SERVICE BULLETIN

APPLICABILITY: 2019-20MY Forester

NUMBER: 12-299-20

SUBJECT: Driver's Seat Hinge Cover- Design Change

Enlarged View of Damaged Claw

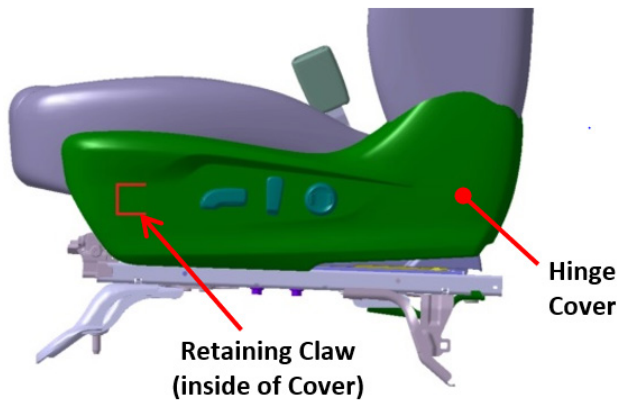
This bulletin announces a design change made to the outer hinge cover on the driver's 10-way adjustable power seat. The change has been made to address several reports about the cover coming loose over time as a result of getting into and out of the driver's seat. The retaining claw portion securing the cover to the seat frame has been changed to improve its strength and durability.

The new Hinge Cover was incorporated into production starting with VIN **LH508731**.

The part number for the new Hinge Cover is **64115SJ231VH**.
